# Administrative Action Preliminary Subdivision / townhome

**Case File / Name:** S-31-10 / Seville @ Brier Creek

**Nature of Case:** Approval of a townhouse development consisting of 152 townhouse lots, 5 open space lots on a 15.29 acre tract, zoned TD/CUD, PDD with SHOD-2 overlay.

S-31-09 Site Map

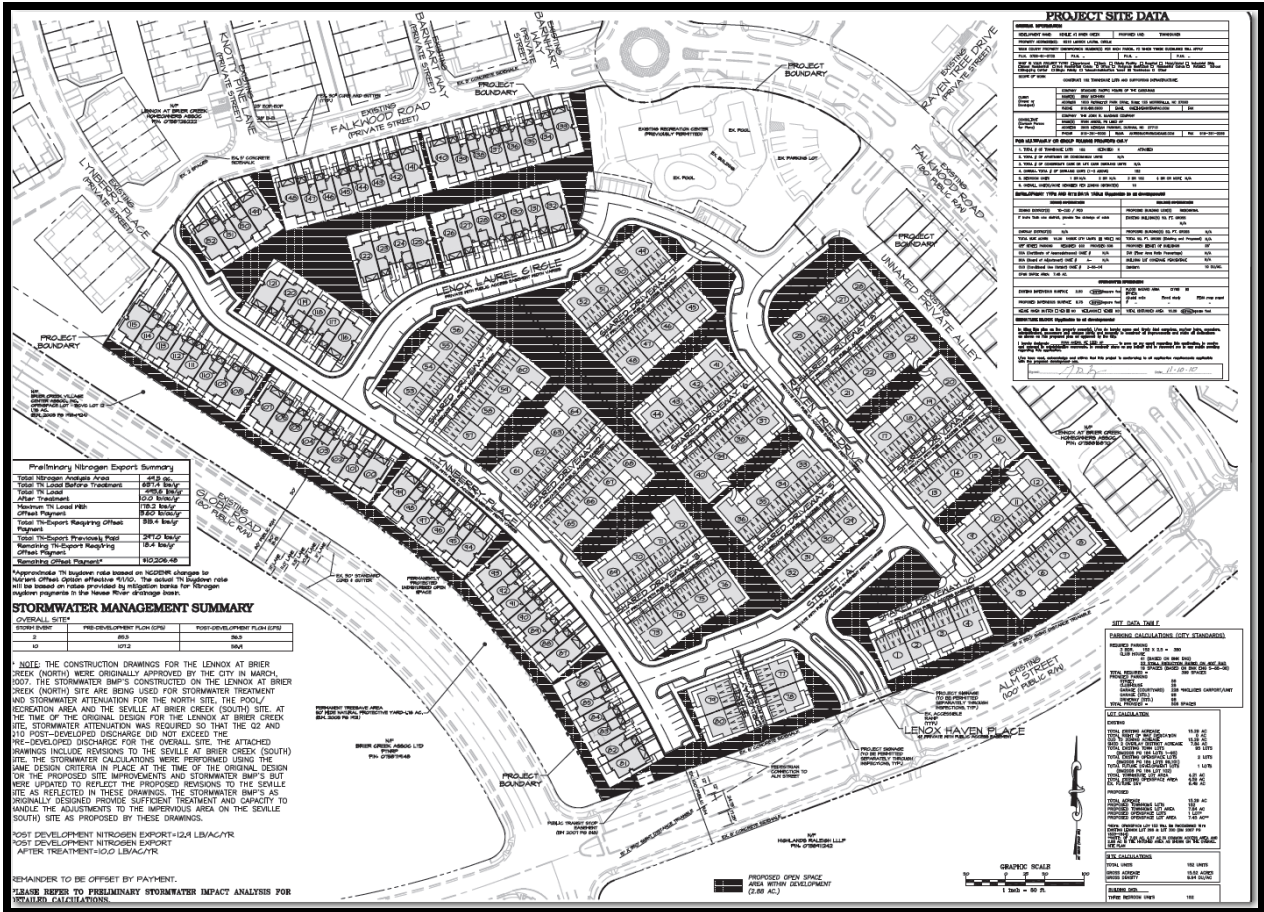
*Please provide sidewalks on both sides of Lenox Laurel Circle shown on the plan.*

- While Policy T 5.5 Sidewalk Requirement applies, due to strict impervious thresholds and site development constraints not all streets are able to have sidewalk on both sides of the street, namely Lynnberry Place.
